REQUEST FOR PLANNING COMMISSION ACTION

Meeting Date:		June 6, 2024					
Item Name:		PUBLIC HEARING - Variance (After-the-Fact) - 854 Beach Road					
Originating Department:		Community Development					
Presented by:		Lane Braaten					
Previous Commission Action (if any):

Item Name: SITE PLAN and DESIGN REVIEW - Goodwill Waconia

PERMEABLE SURFACE SURVEY

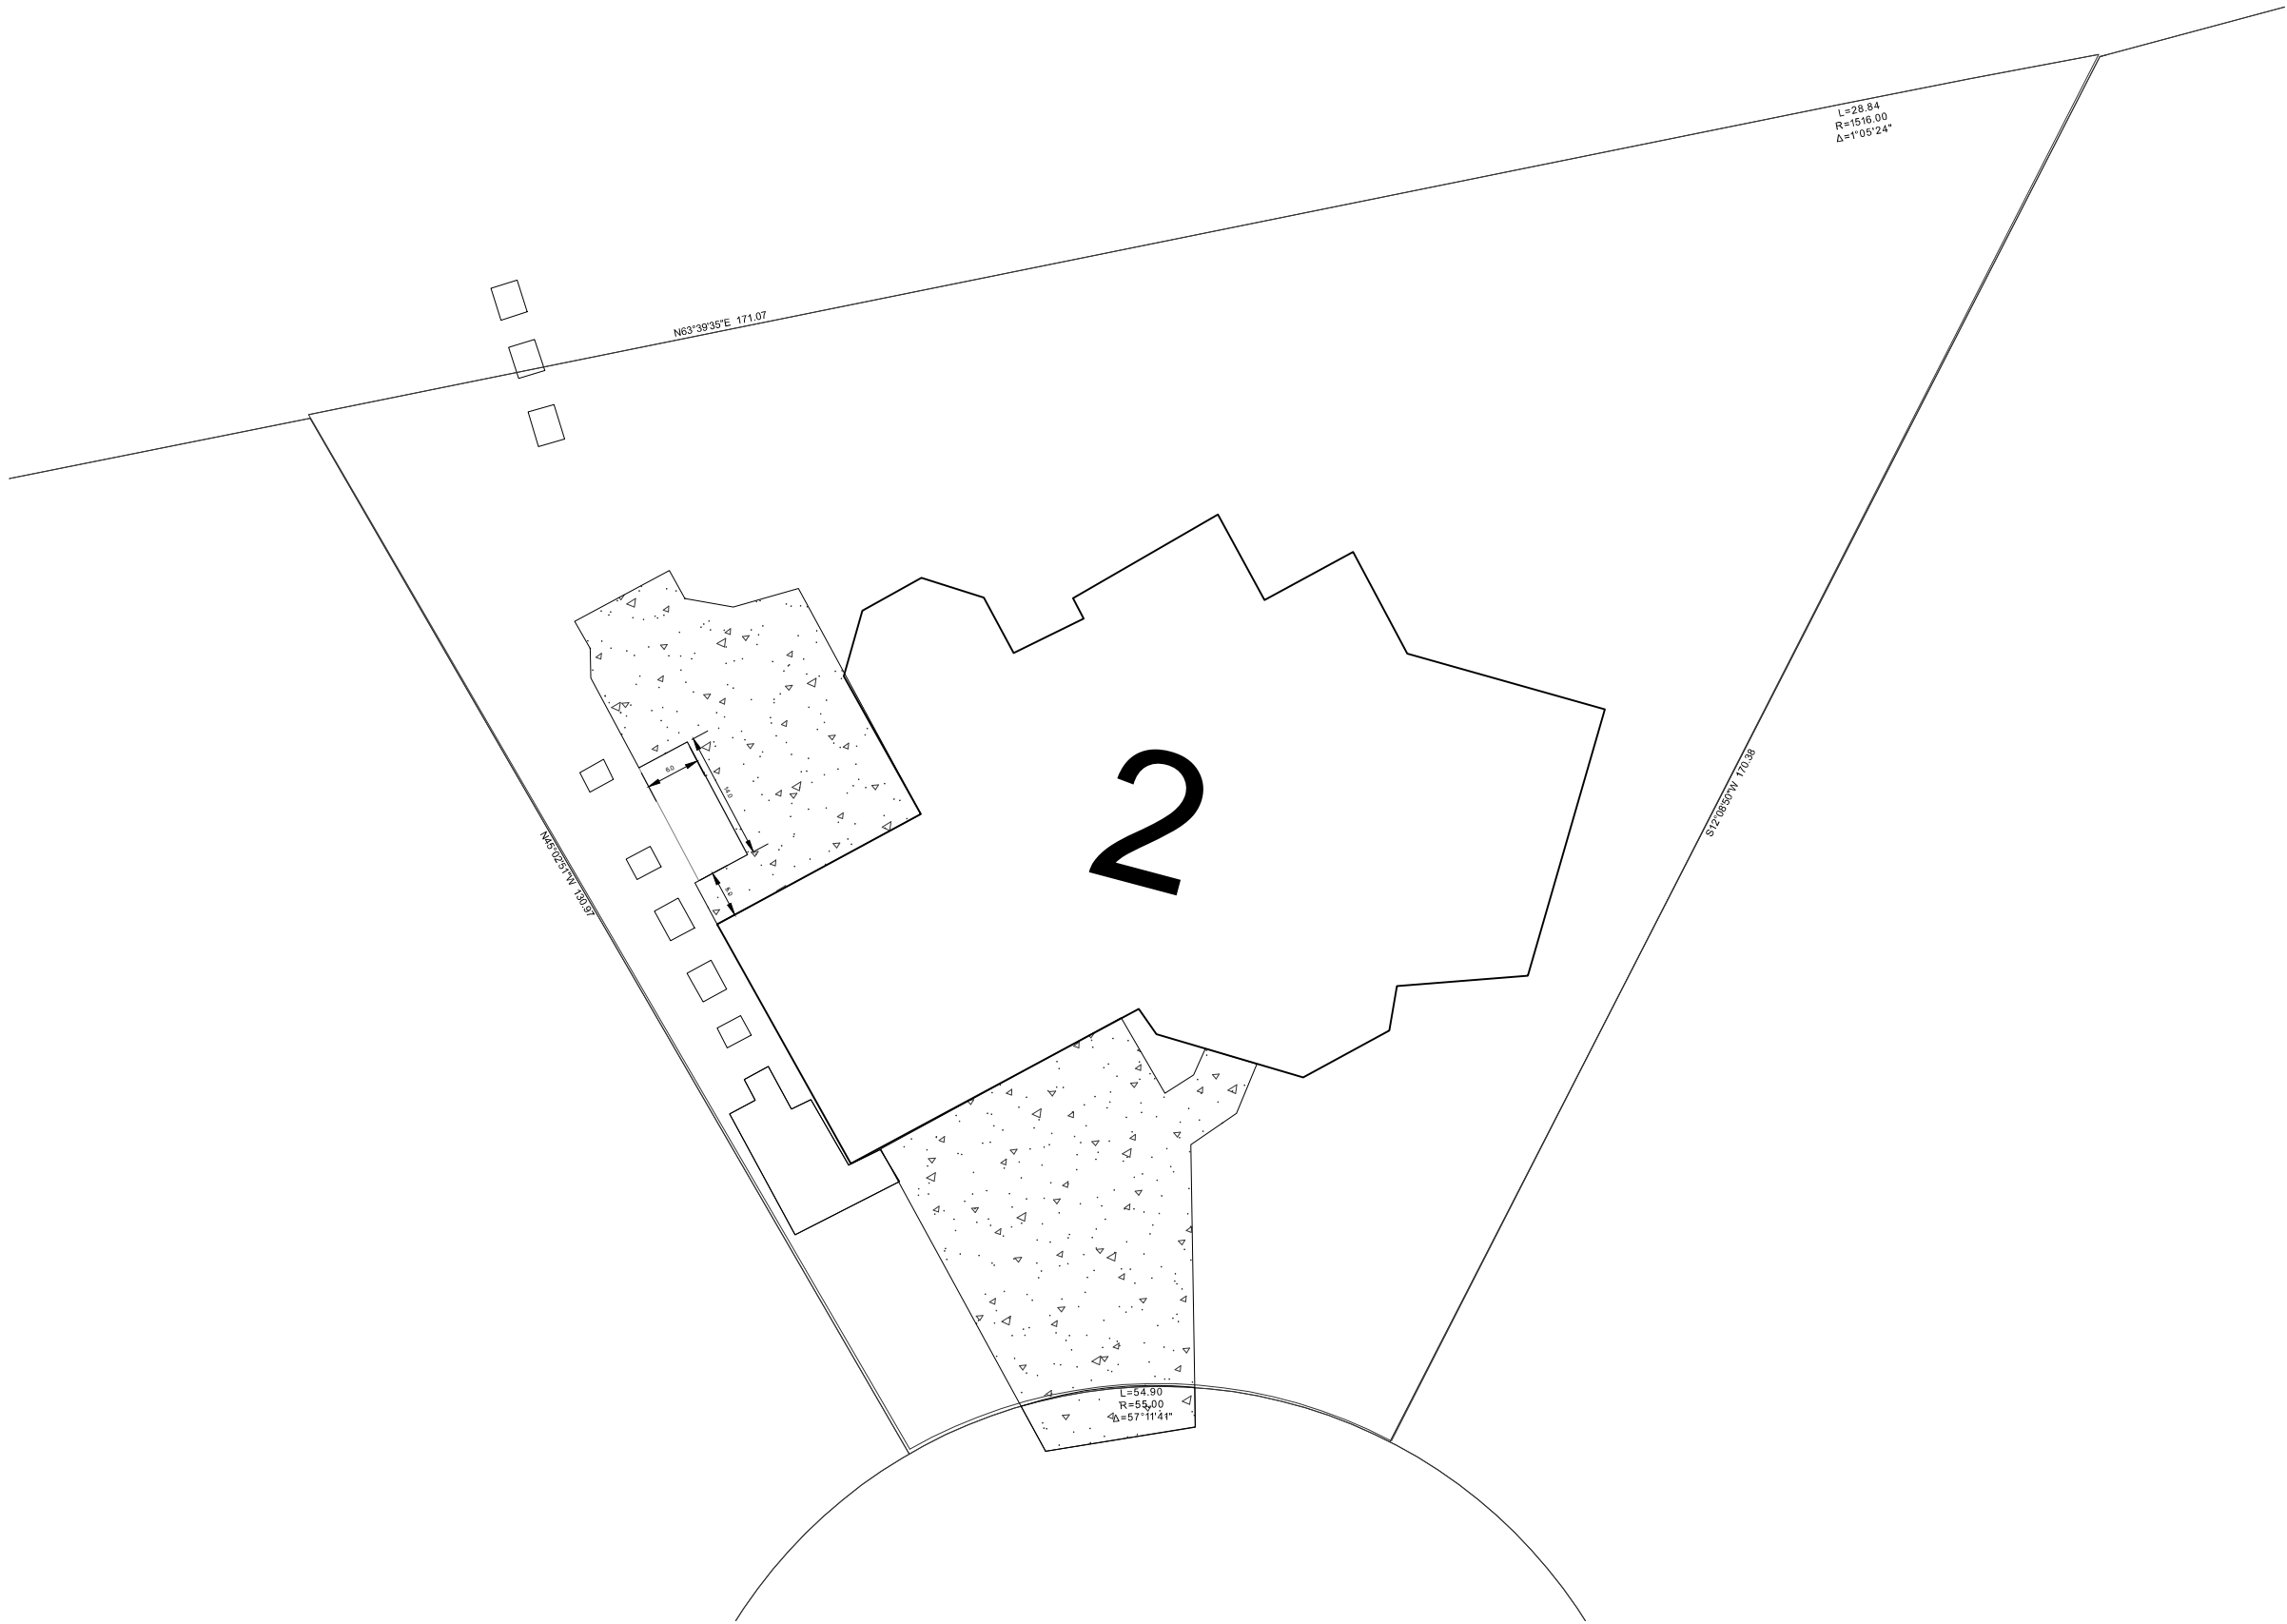
- KEYNOTES:
- 16,145.3 Total Lot Area -
 - 5835.53- Current impermeable surfaces area
 - 2.1. 36% Hard surface total

We are submitting an after the fact variance request for 854 Beach Road. Our request is for a variance to allow a 1% overage of hard cover surface to the property.

The property owner working with Graham Anderson has come up with a plan to make corrections to the overage by removing sections of the hard surface. With the proposed areas being removed, this would bring the percentage of overage down to 1%. The proposed solution to the remaining 1% overage would be to remove the interlocking sand from 2% of the existing hard surface and replace the interlocking sand with permeable interlocking sand. An annual maintenance plan would also be set in place to maintain permeability in this area. By doing this, it would actually bring the hard surface percentage down to 34%.

Correction plans:

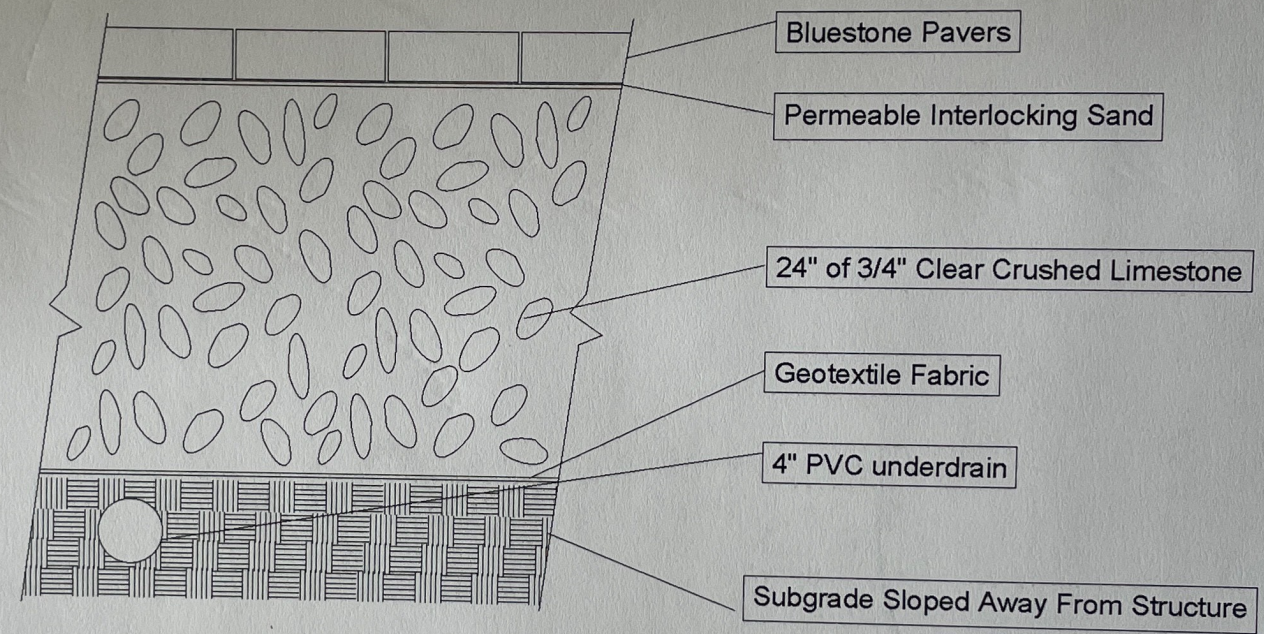
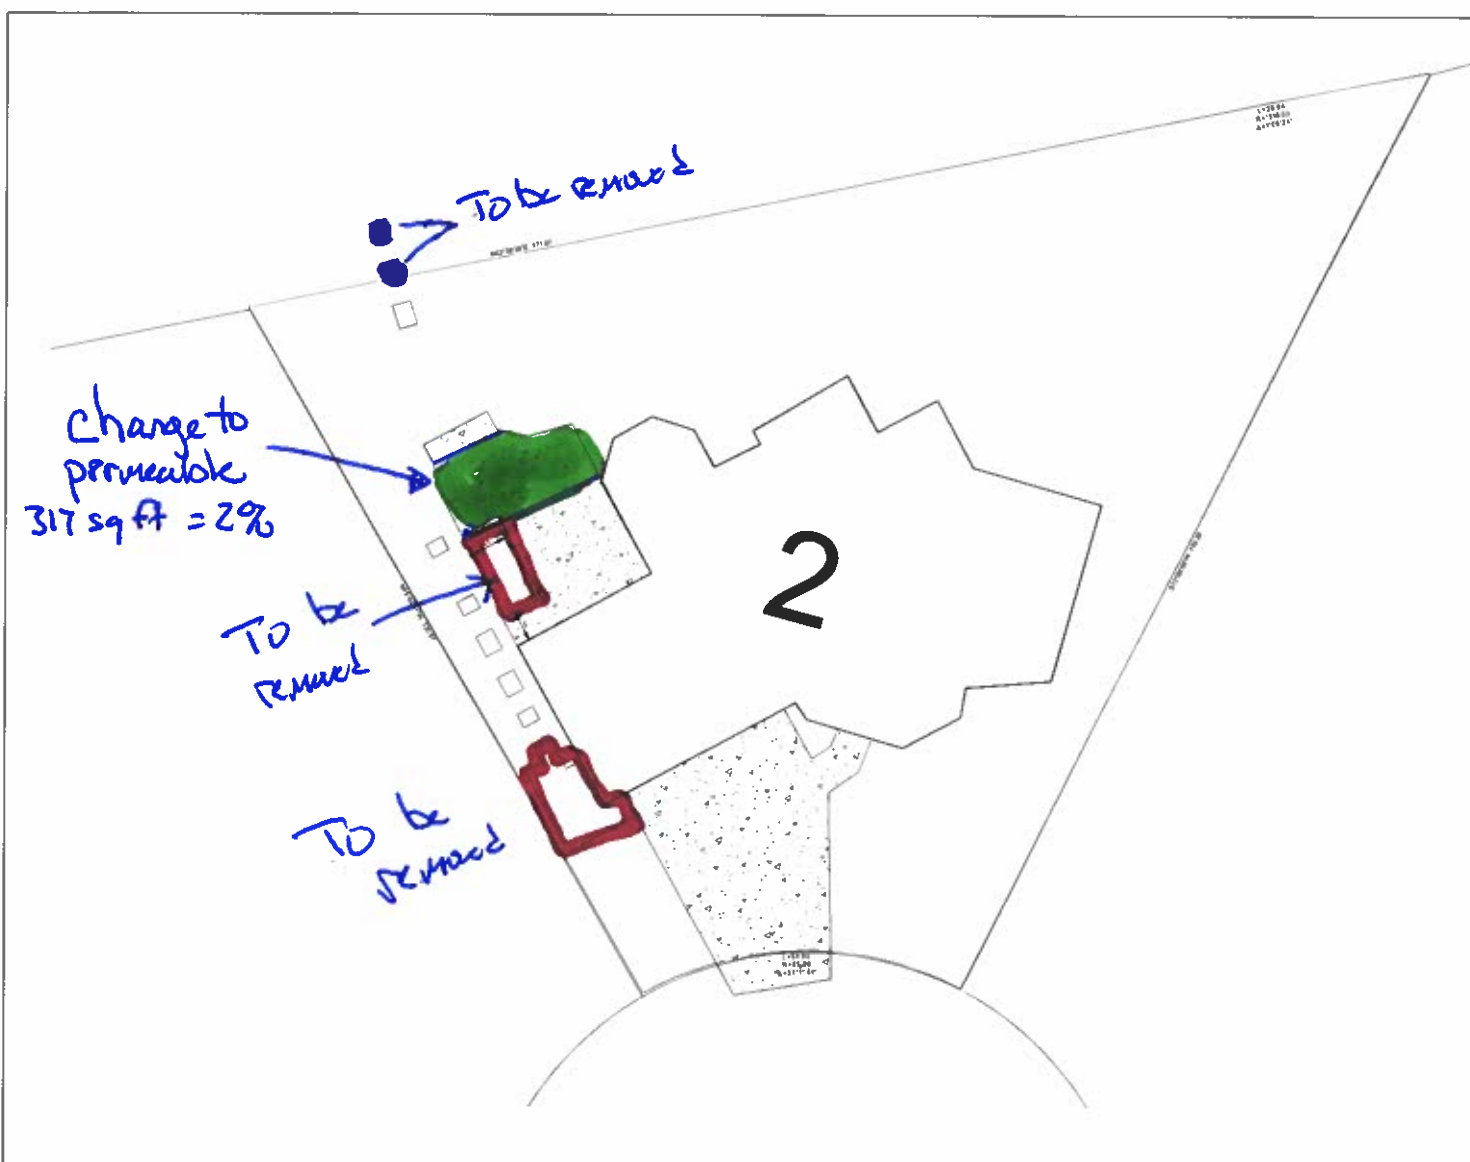
1. Remove marked areas under deck stairs and in and around garbage enclosure. We will remove the bluestone pavers and inst landscape beds with crushed stone.
2. Power wash and remove interlocking sand from bluestone paver patio as marked on plans. We will then install permeable interlocking sand in the joints. This would require an annual maintenance plan of power washing once a year to keep the the joints clear of debris allowing water to flow through.
3. Remove hardscape (steps) along the back of the property line to bring all hardscape within the property line.

- The policy in Waconia has been to NOT accept permeable pavements as a BMP/pervious surface for private properties. The pervious pavements/pavers are difficult to maintain and need specialized equipment. Unless the City monitors yearly to make sure the homeowner is completing proper maintenance, and make replacements as necessary, the BMP will not work as designed. This setup also becomes more complicated when the property eventually changes owners.
- All improvements outside the property line are recommended to be removed, including the mulch bed and plantings to the north along the City trail. Even if a maintenance agreement were to be executed, the mulch bed area would likely become a City maintenance item at some point if it were to remain.

GRADING PLAN

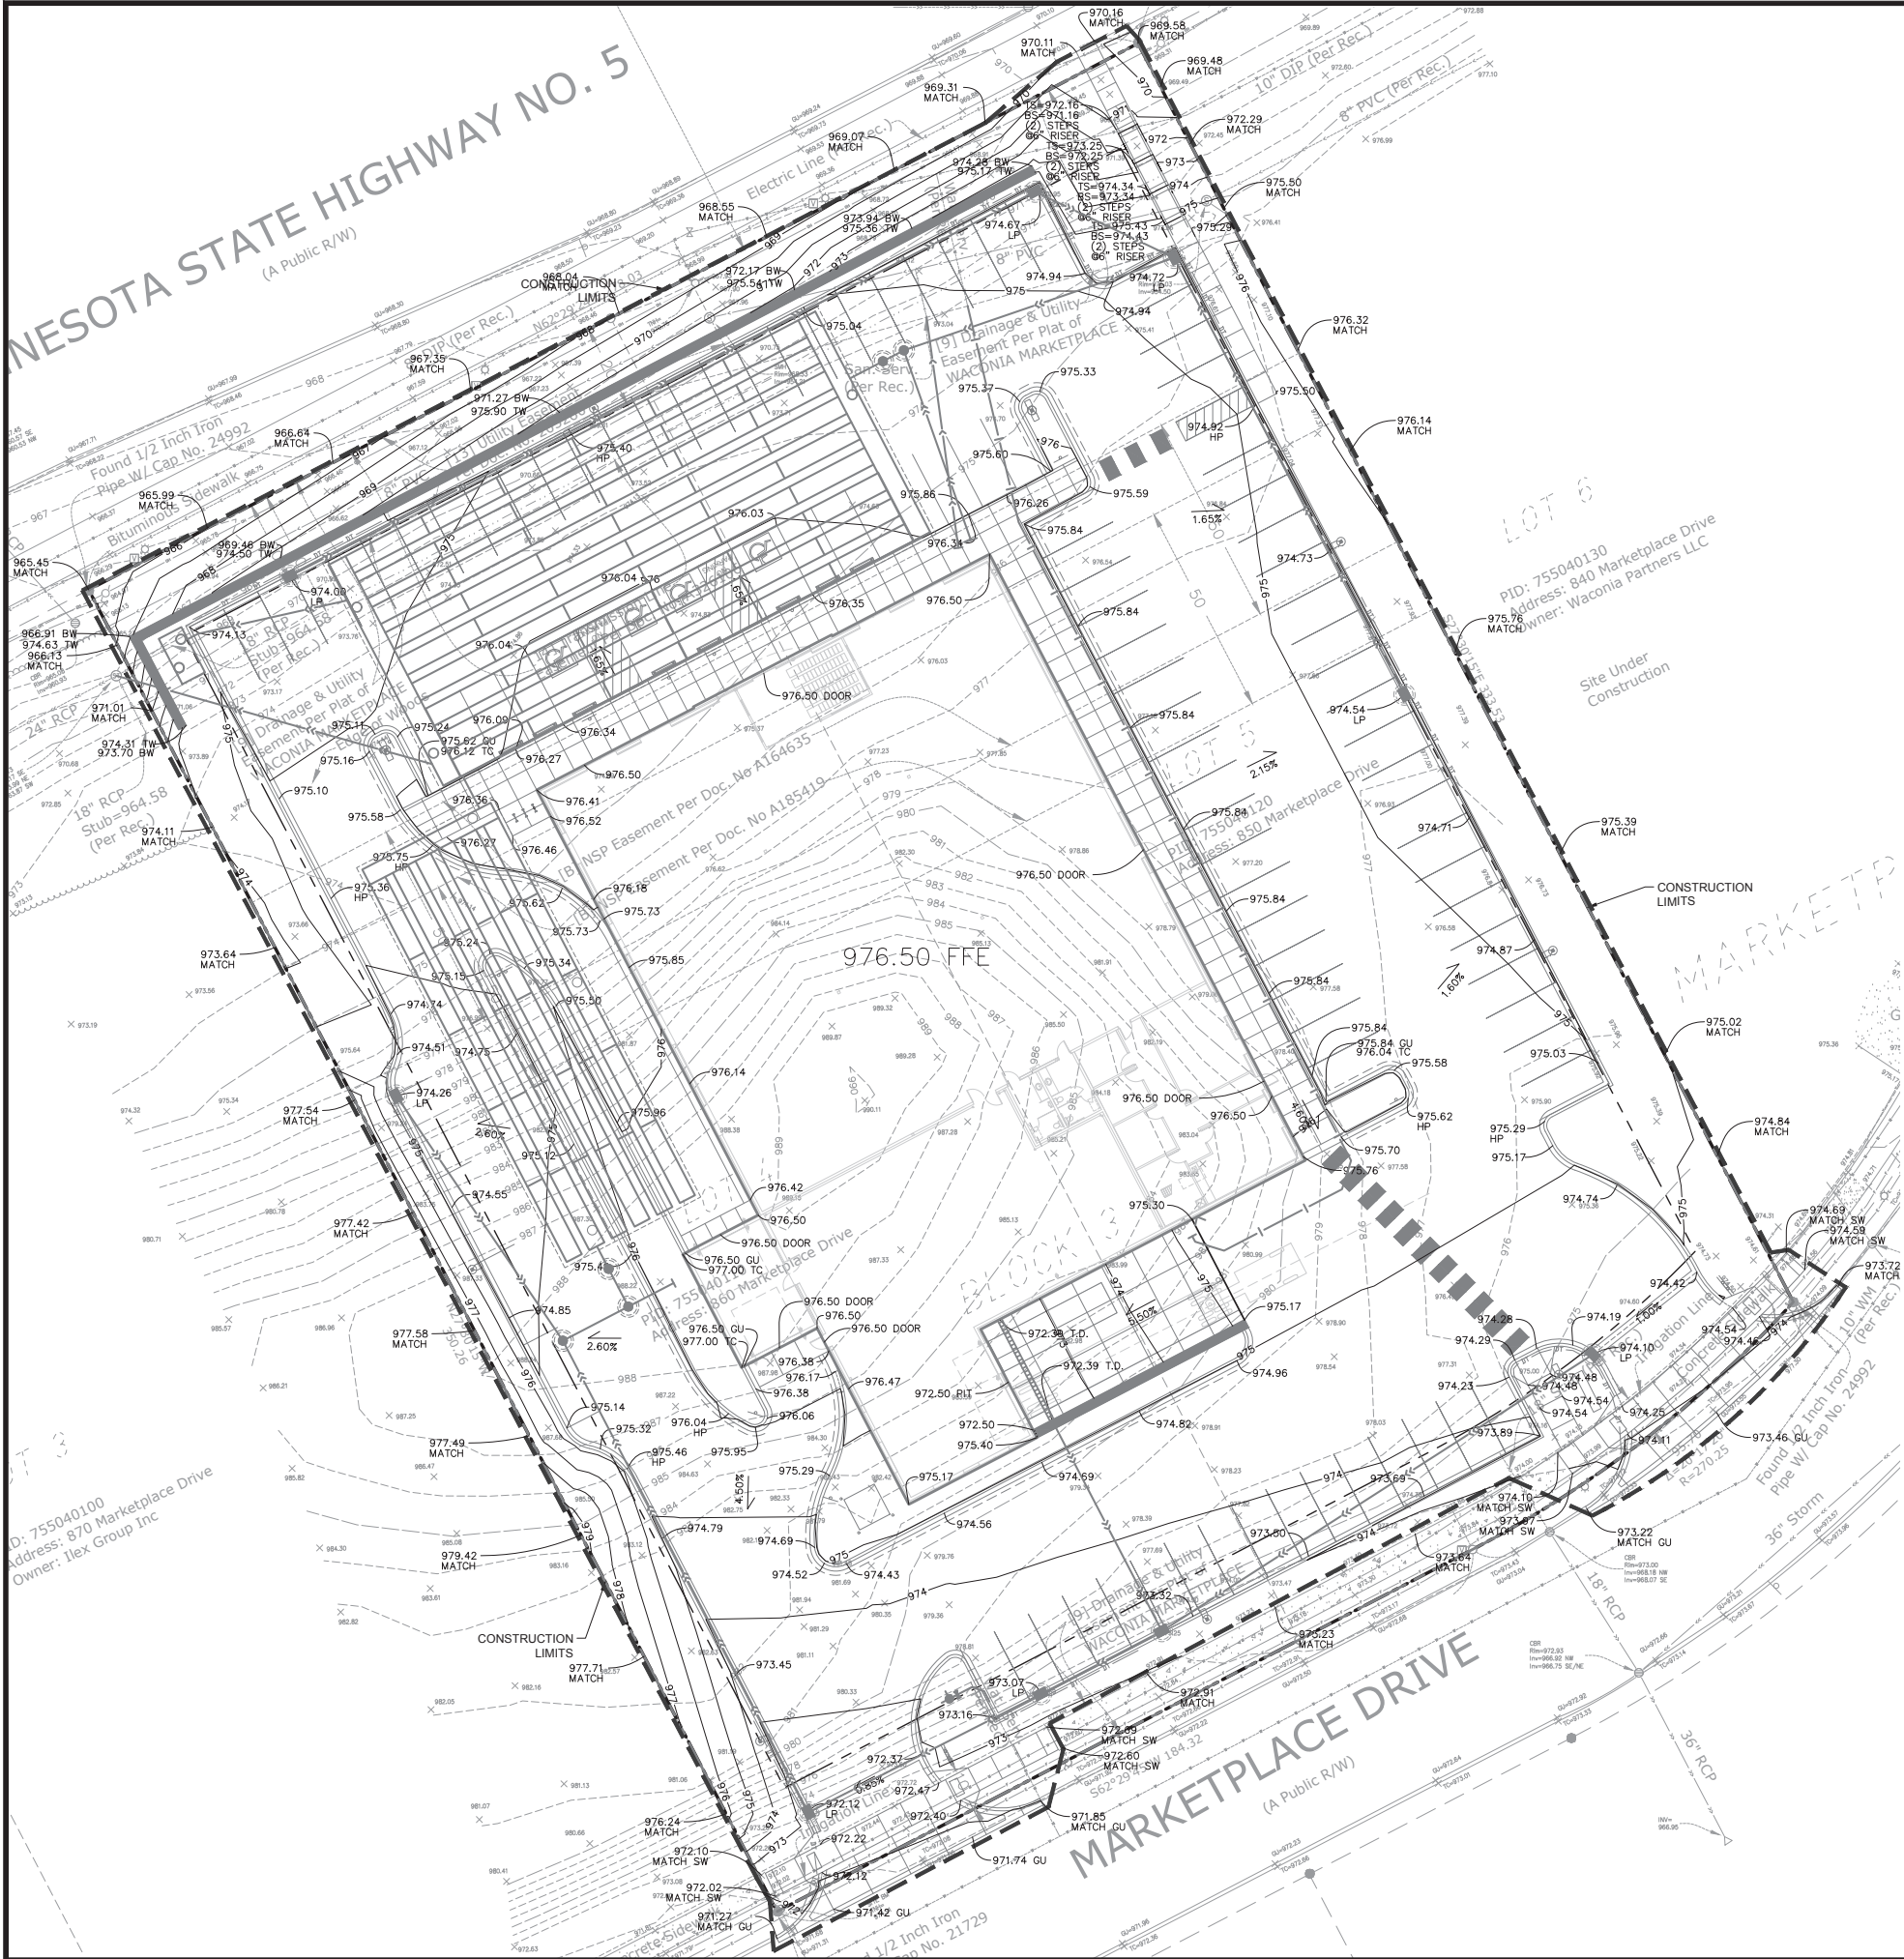
The utility, grading and storm water information has been reviewed by the City Engineer. There are a few outstanding items which require resolution, but nothing significant enough to preclude the Planning Commission and City Council from reviewing the site plan application. Any recommendation of approval shall require the applicant to work with the City Engineer to revise the grading, drainage, and utility information to the satisfaction of the City prior to any work commencing on site.

3. The applicant shall work with the City Engineer to revise the grading, drainage and utility information to the satisfaction of the City prior to any work commencing on site.
